Meeting Agenda Plat Committee

Monday, November 14, 2022

1. [KPB-4734](#) ASLS No. 2021-37 North Fork Micro AG Subdivision; KPB File 2022-158

A SUBDIVISION OF
 SURVEYED SECTION 36
 TOWNSHIP 4 SOUTH, RANGE 14 WEST, SEWARD MERIDIAN, AK
 LOTS 1-3 BLOCK 1; LOTS 1-4 BLOCK 2; LOTS 1-3 BLOCK 3;
 LOTS 1-7 BLOCK 4; LOTS 1-3 BLOCK 5; LOTS 1-3 BLOCK 6;
 AND TRACT A
 CONTAINING 640 ACRES MORE OR LESS
 HOMER RECORDING DISTRICT

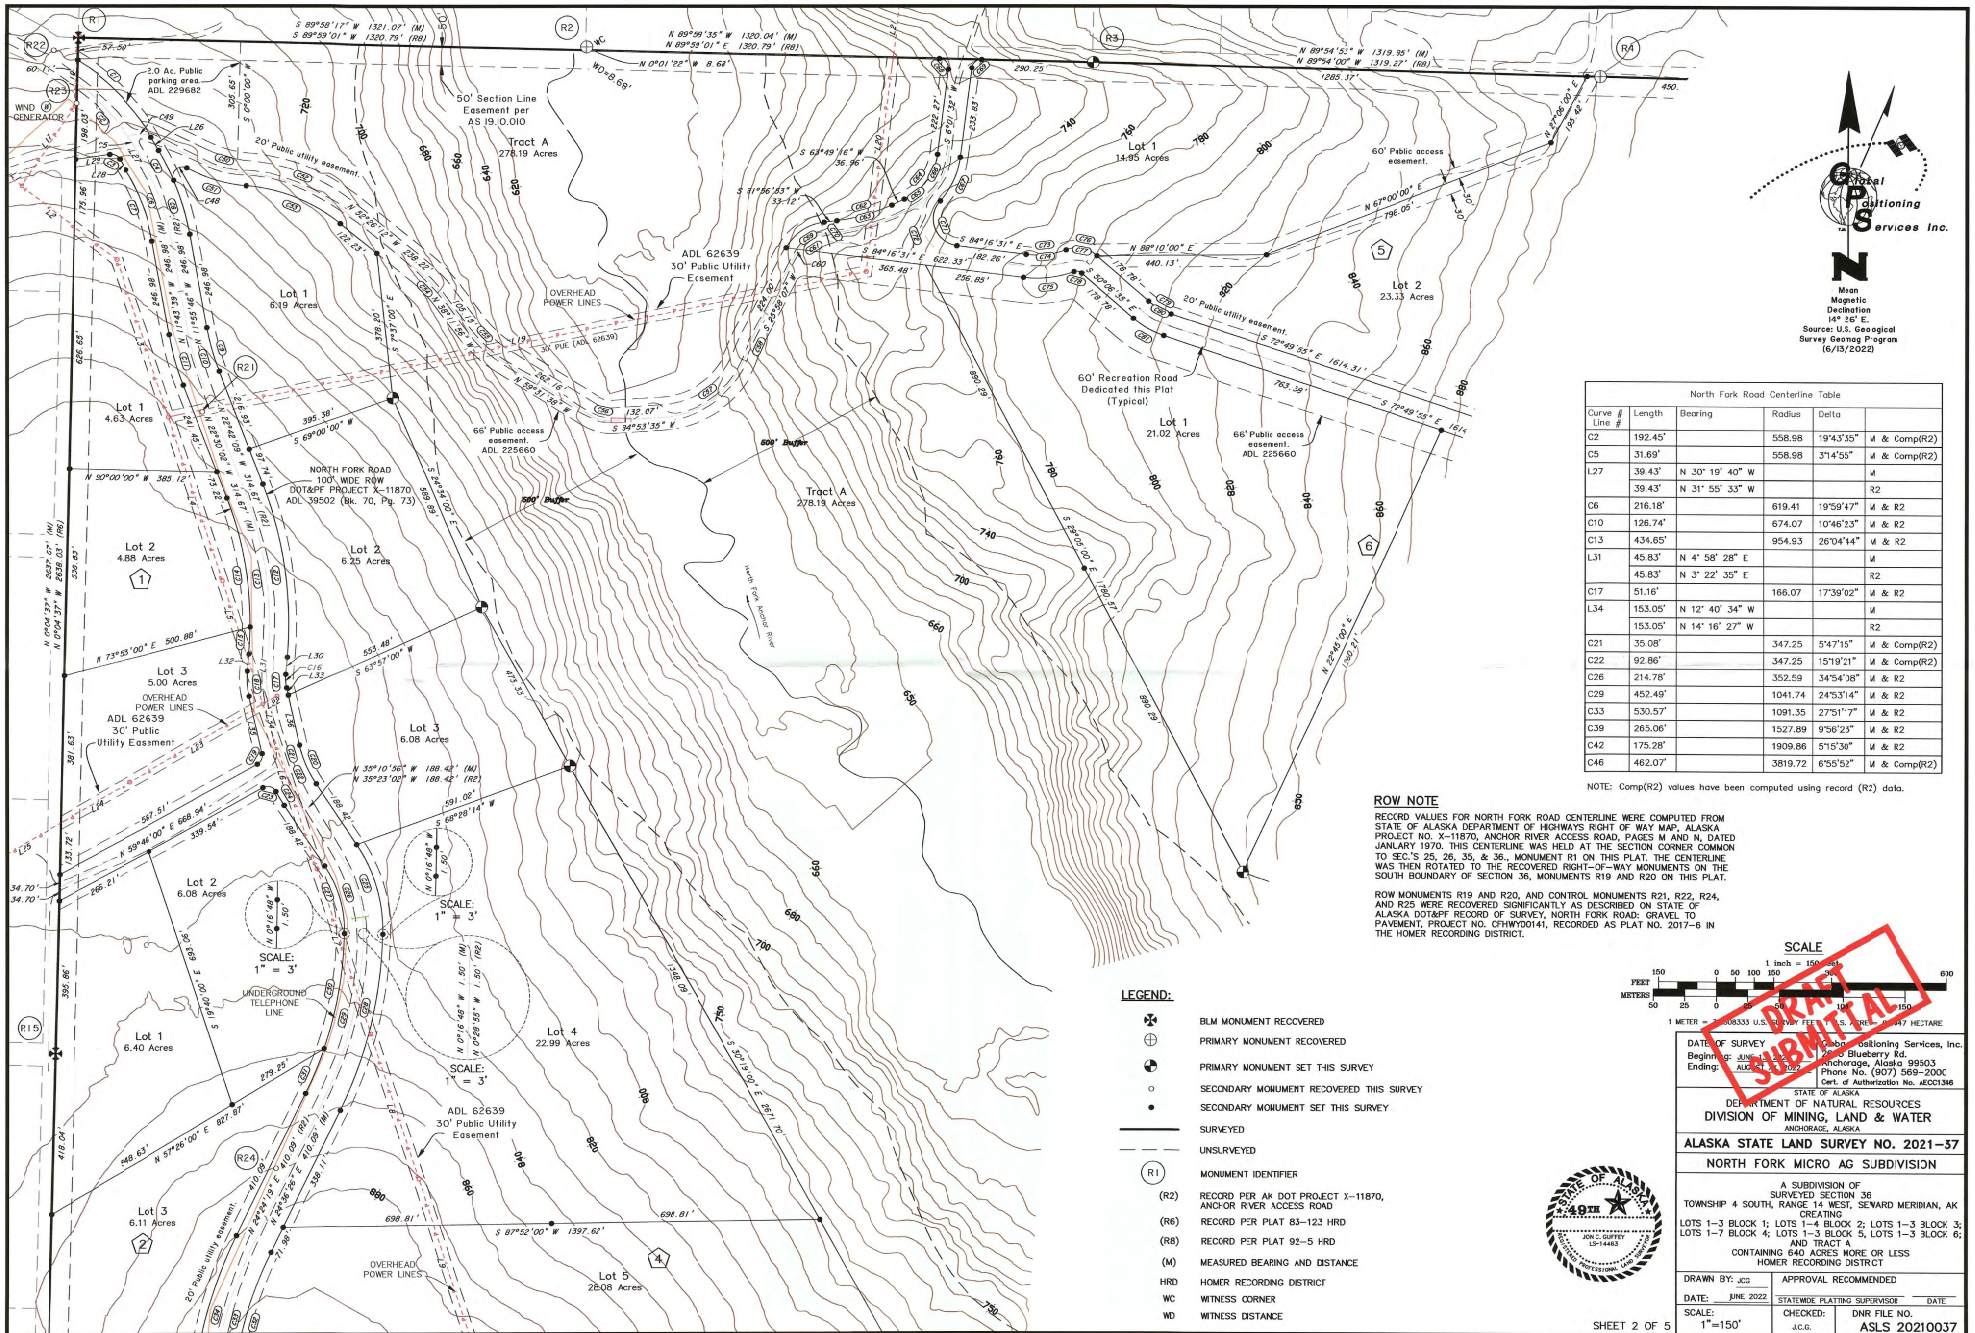
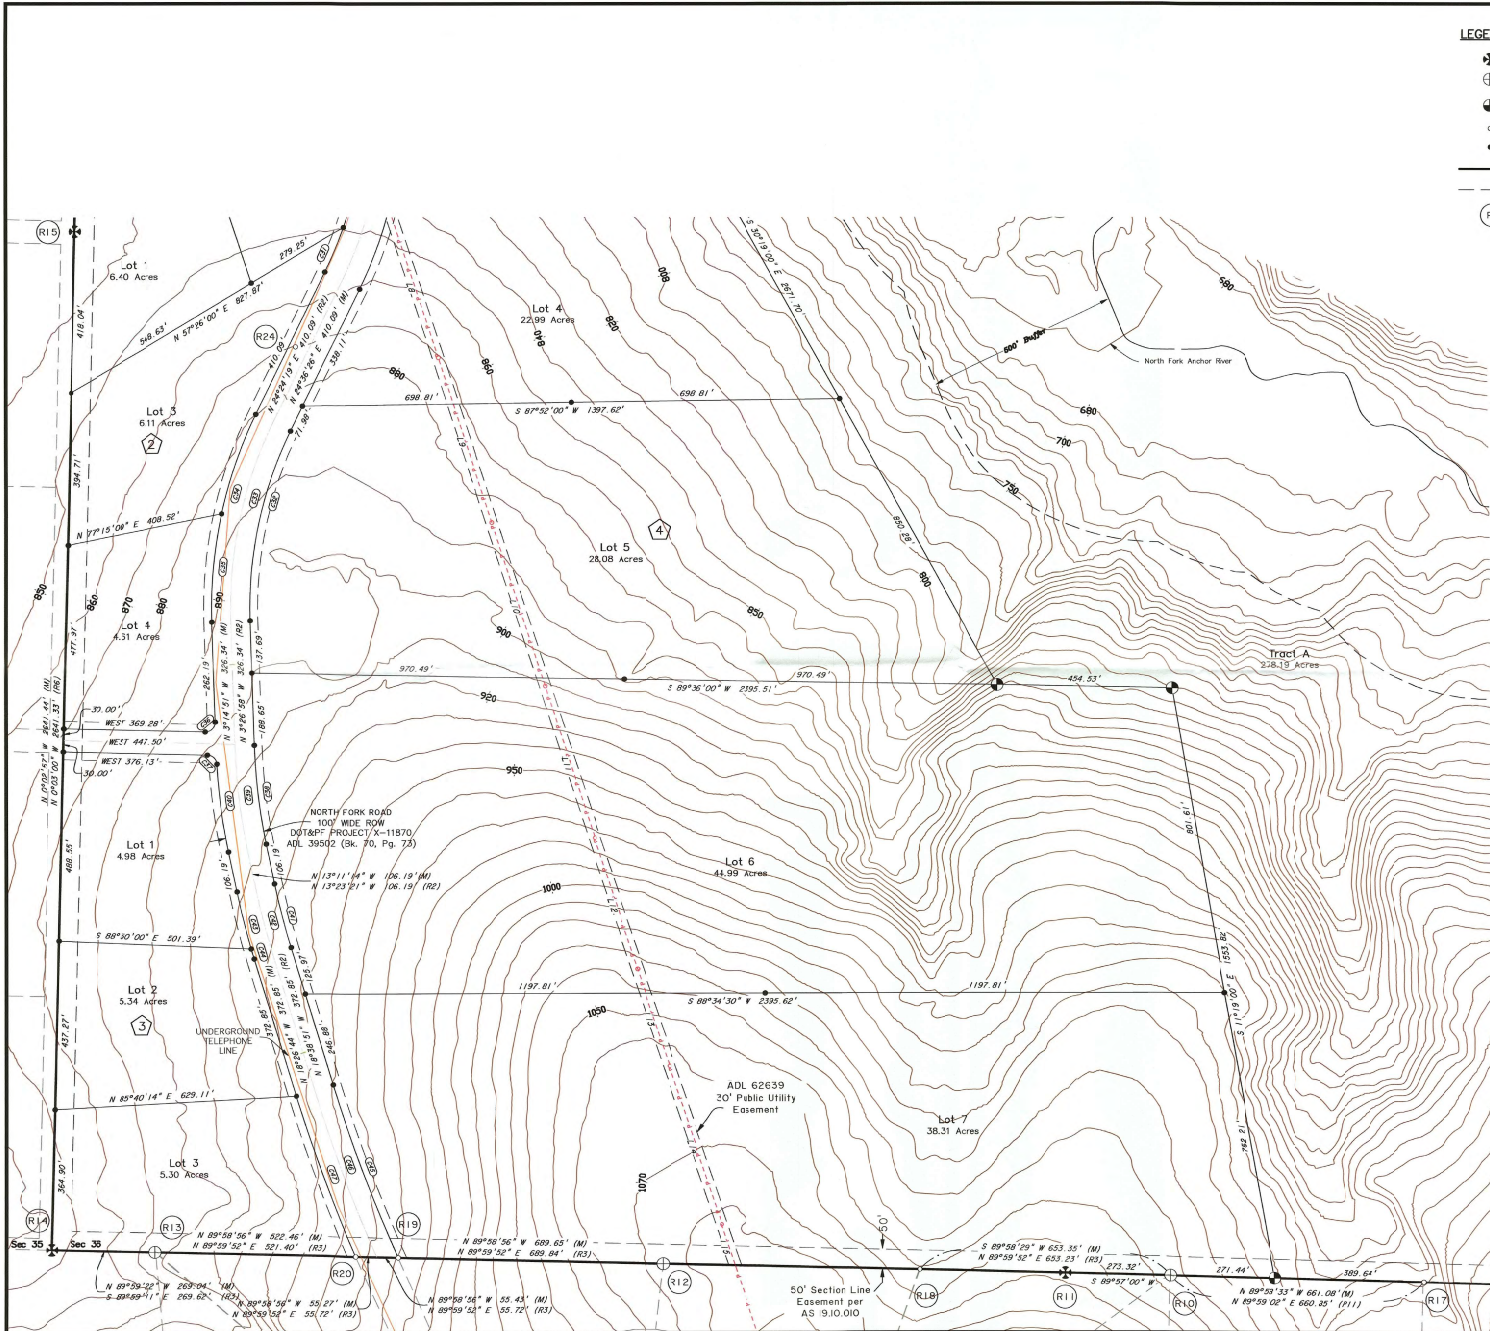
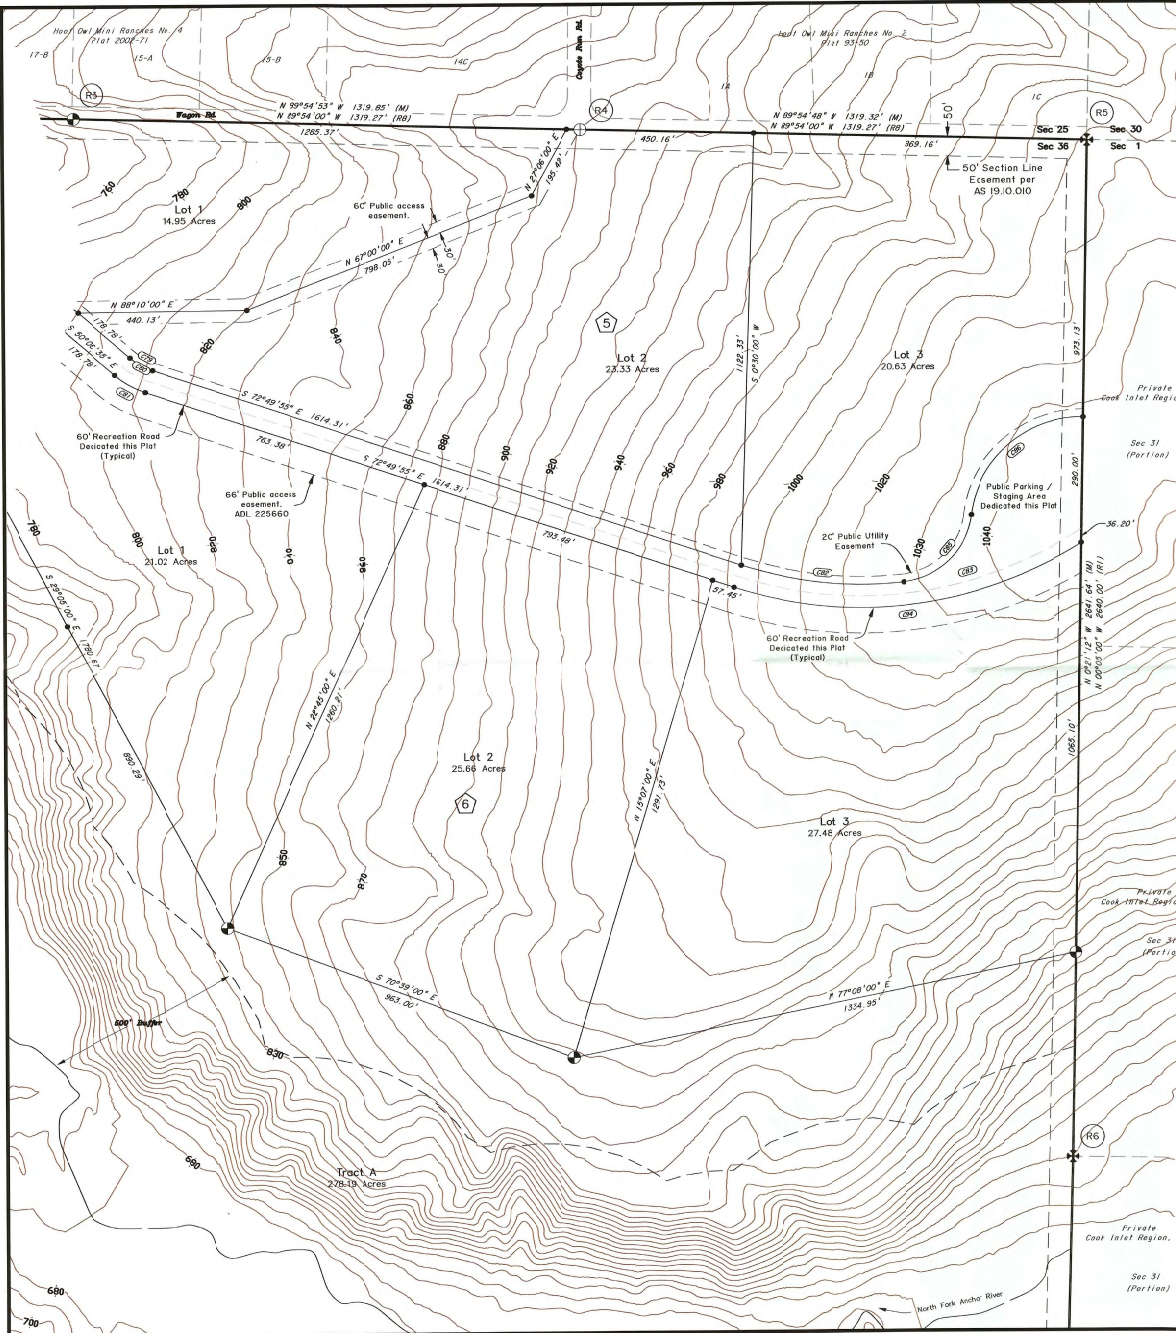
Section line easements exist around the perimeter of the subdivision and have some labeling. ***Staff recommends a different line style be used to depict the section line easements so minimal labels can remain but the legend will clarify the status of the line shown.***

KPB Code requires minimum 10 foot utility easements adjacent to rights-of-way. Staff is requesting additional dedications to provide for matching dedications. **Staff recommends 10 foot utility easements adjacent to all dedications within the subdivision with a required plat note, if depiction is not possible, a typical detail depiction may be used.**

The preliminary plat was submitted as a 4 page document. Unless a 5th page is going to be added at final, update all pages to state of 4 sheets.

Staff recommendation: *The mailing address for the owner is required. Within the information for the subdivision, Kenai Peninsula Borough and State of Alaska should be added to the location information. The KPB File number of 2022-158 should be added in or near the title block.*

Staff recommendation: *Plat note is needed and depiction must be provided. If unable to depict a typical depiction detail may be used.*

Staff recommendation: Acceptance for rights-of-way will be required. The notary shown is a combination of Acknowledgement and jurat. Remove "sworn" or change to Notary's Jurat. Comply with 20.60.190.

KPB 2019-040R1

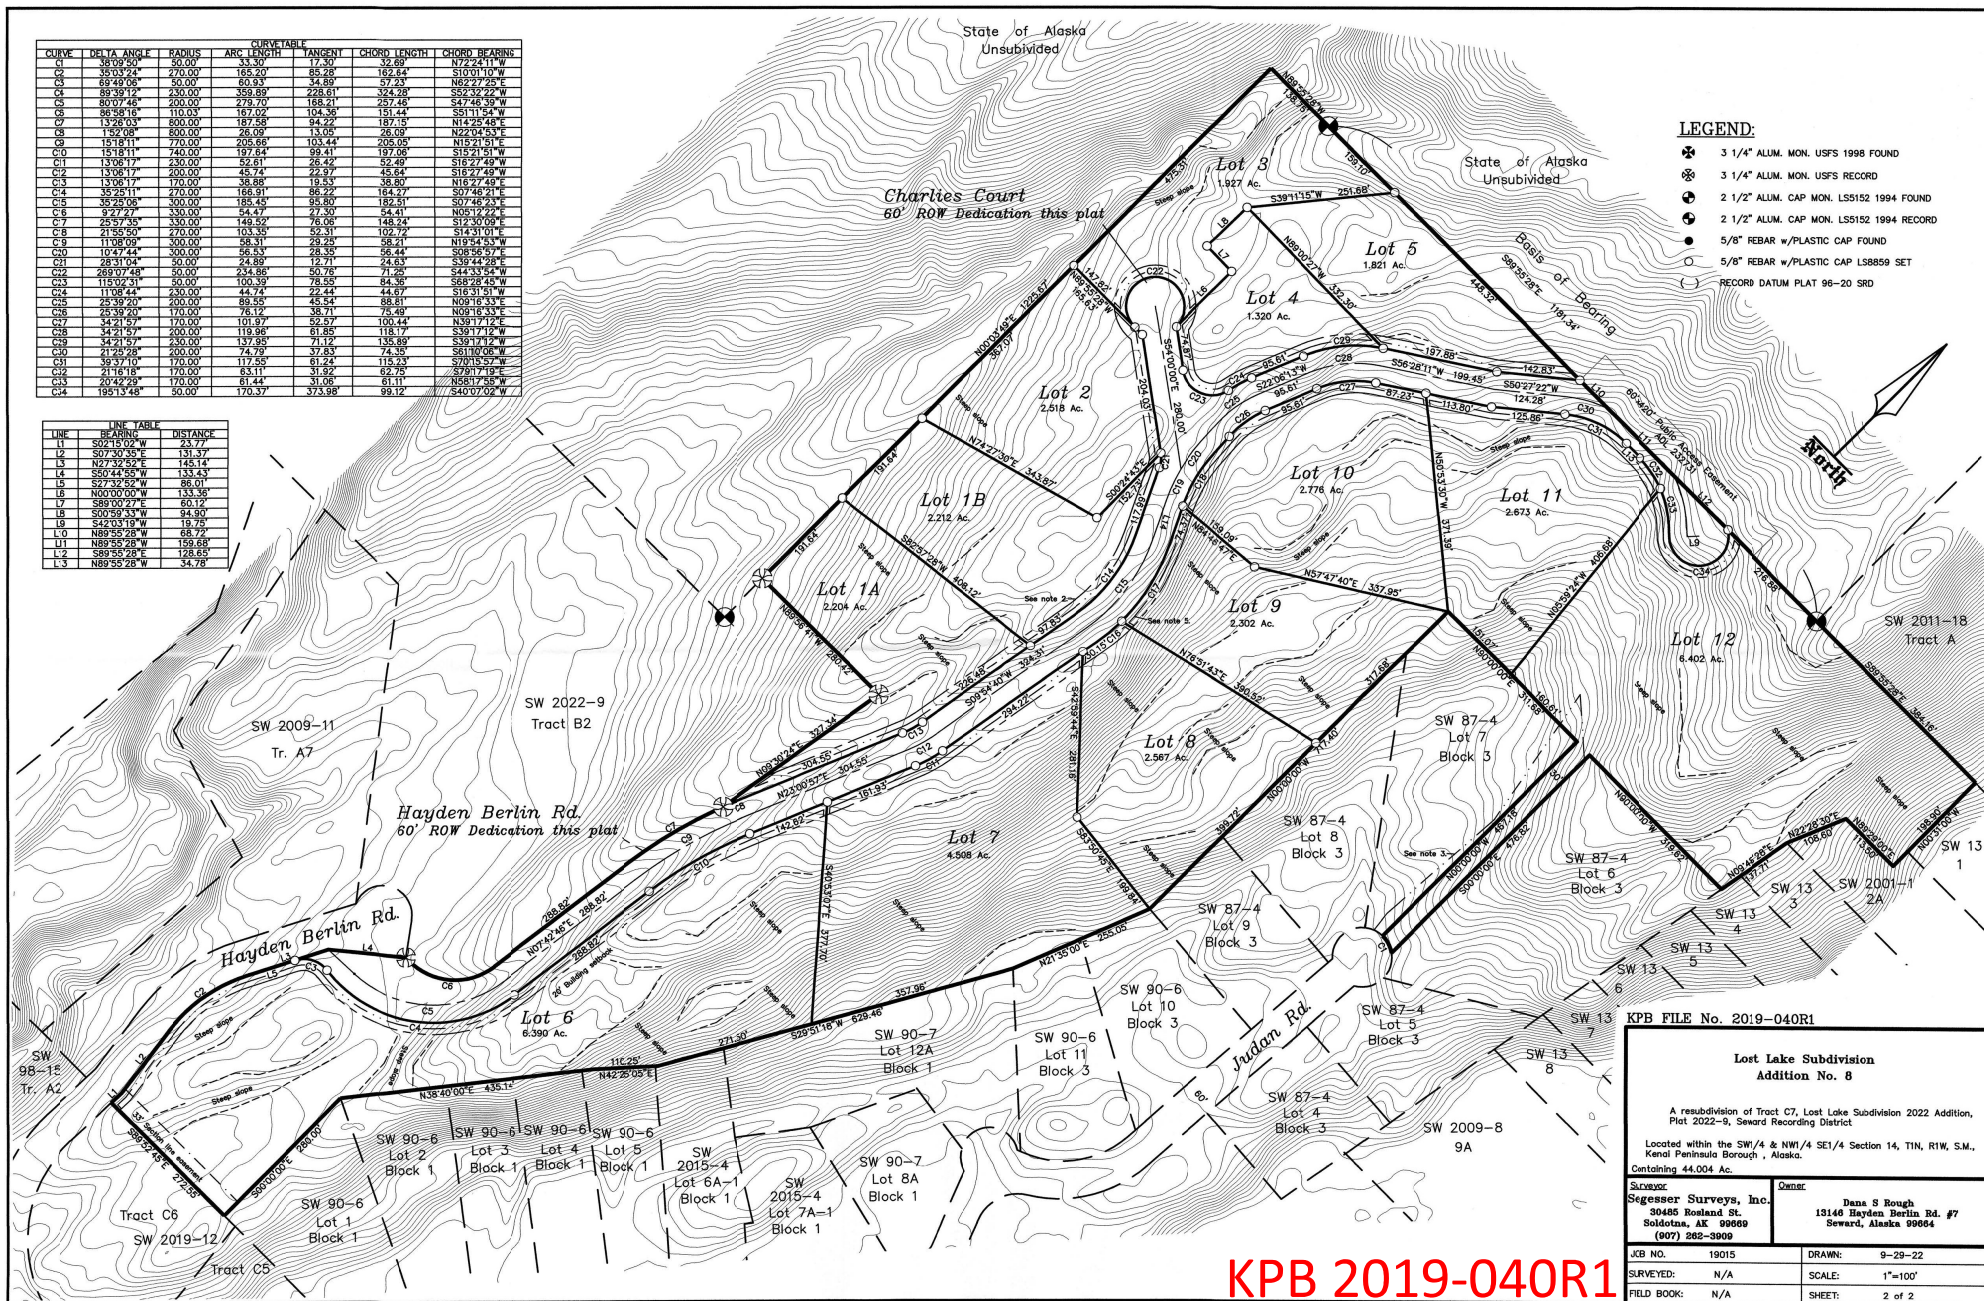
- Staff recommendation:** On sheet 1 – correct some of the overstrikes, provide the recording number for the lot shown in the northeast. Update Lot 6A from SW 2015-4 to 6A-1 and Lot 7A to 7A-1. On both sheets – provide the label “Lot” for the lots created by SW13. C6 and C5 south of the subdivision were designated as “Lot” on the plat. Update their labels.
